Assessment of Dam Safety of Coal Combustion Surface Impoundments

Coletto LP, LLC

August 4, 2010

Draft Report

**PRIMARY ASH POND
EAST EMBANKMENT STABILITY ANALYSIS**
FIGURE 9

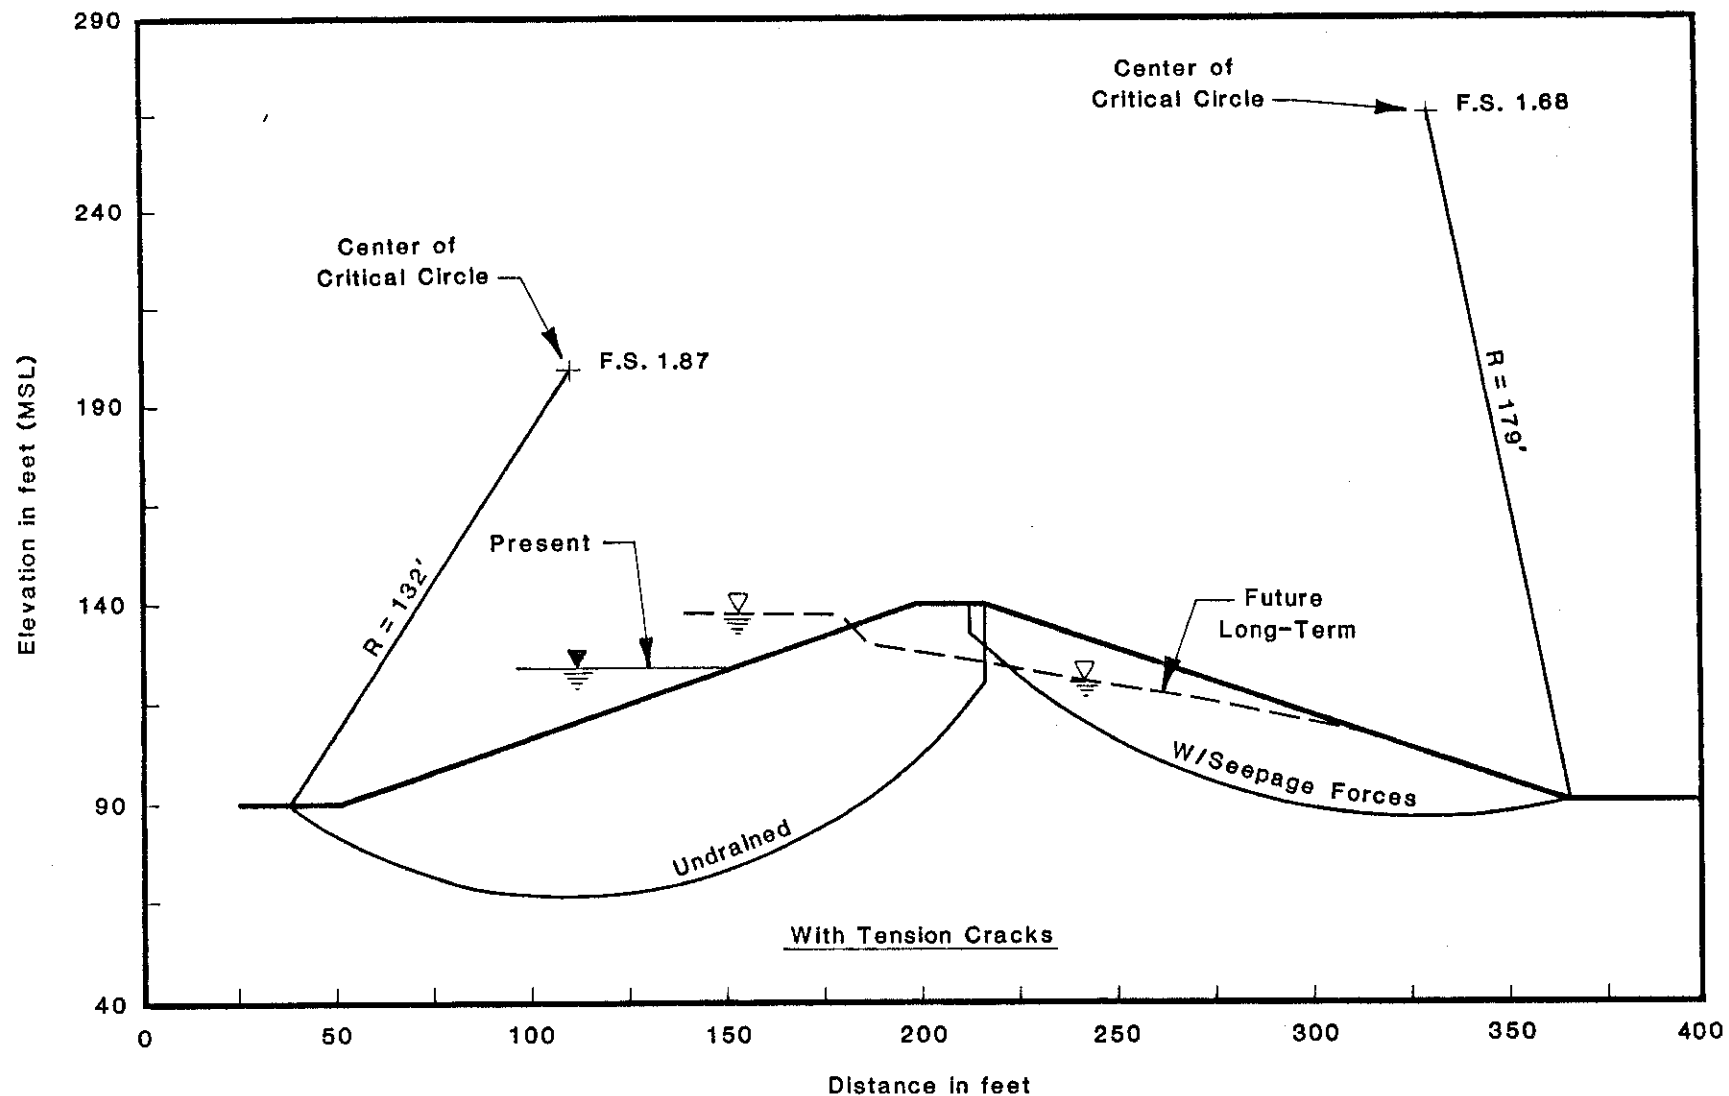
The interior slope of the Primary Ash and Secondary Pond was evaluated under undrained conditions. URM performed the analyses assuming a pond water level of El. 125. Although not specifically indicated, it appears that this analysis may have been selected to model a drawdown condition. The results of the undrained analysis for the primary ash and Secondary Pond embankments are shown on [Figures 9 and 10](#), respectively. Figures 9 and 10 indicate the factor of safety against slope stability was 2.21 and 1.87 for the primary Ash and Secondary Pond interior slopes, respectively.

The exterior slope of the Primary Ash and Secondary Pond was also evaluated under long-term steady-state conditions assuming a normal pool elevation of El. 135. For the steady-state analyses, URM assumed effective soil strength parameters. The results of the drained analysis for the Primary Ash and Secondary Pond embankments are shown on [Figures 9 and 10](#), respectively. Figures 9 and 10 indicate the factor of safety against slope stability was 2.37 and 1.68 for the Primary Ash and Secondary Pond exterior slopes, respectively, which is greater than the minimum required 1.5. It

should be noted that the stability analyses performed almost 30 years ago and utilized a normal pool level that is two feet lower than the current normal pool level of El. 137.

In addition, URM's evaluations did not consider the following load cases:

- Maximum surcharge pool (flood) condition;
- Rapid drawdown condition;
- Seismic loading; or
- Liquefaction.
